## **TECHNICAL BULLETIN**

DATE: 6 FEBRUARY 1978

# REMOVAL OF CAPACITOR – VOLTAGE REGULATOR, \*AAE OR LSI MODEL VR204; INSTALLATION OF VARISTOR – LANDING LIGHT RELAY, PN 369A4558 OR MSI4166D1

Figure 1. Field Rework - Voltage Regulator

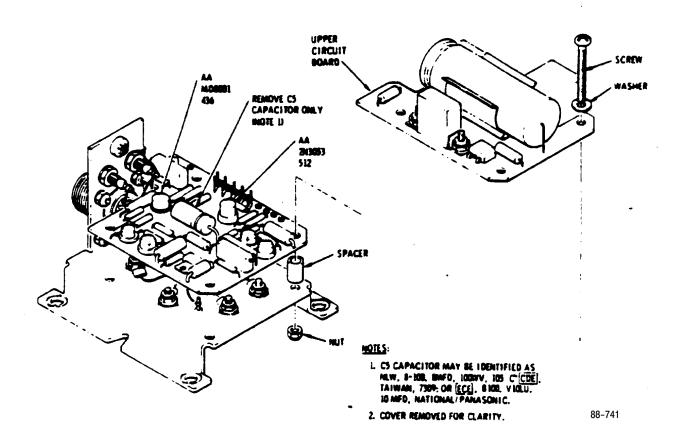
The information given in this Service Information Notice lists a procedure for removal of the 8  $\mu$ fd capacitor (C5) incorporated in the subject Model VR204 voltage regulator to reduce EMI. The C5 is paralleled by a 1  $\mu$ fd capacitor which accomplishes the same function. Since failure of the C5 due to voltage spikes has been reported, removal of this capacitor is recommended to ensure the operating reliability of the voltage regulator.

- (4). Remove cover from regulator: remove four screws, spacers and nuts securing upper circuit board of regulator. (See Figure I.)
- (5). Remove capacitor C5 as shown; clip wire leads as close as possible to circuit board.
- (6). Reinstall upper circuit board tad cover.
- (7). Using ink stamp, add "MOD 5C" on vendor nameplate to indicate modified voltage regulator.
- (8). Reinstall voltage regulator and attach electrical connector.
- (9). Perform an operational check of the voltage regulator and make adjustments as necessary. (Refer to HMI - Vol 1).
